# Access Compliance Report

## Public Rights-of-Way

| Intersection ID: 11480                  | Main Street: N_CEDAR_ST | Cross Street: W_5TH_ST                  | Location: E            |
| ADA ID: CD67A5B163BD                    | Ramp Type: PerpDiag     | Initial Pass/Fail: Fail                 | Overall Compliance: No |

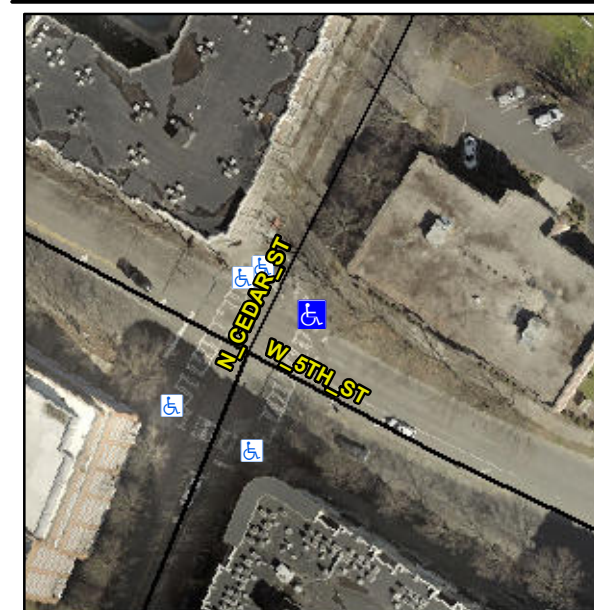
**Not Found, R304.5.1, R304.5.3**

| Compliance | Description           | Data  | Compliance | Description                 | Data  |
|------------|-----------------------|-------|------------|-----------------------------|-------|
| No         | Ramp Width (in)       | 32.0  | No         | Ramp XSlope (%)             | 11.1  |

**Remove & Replace Curb Ramp With Two New Directional Ramps or Equivalent.**
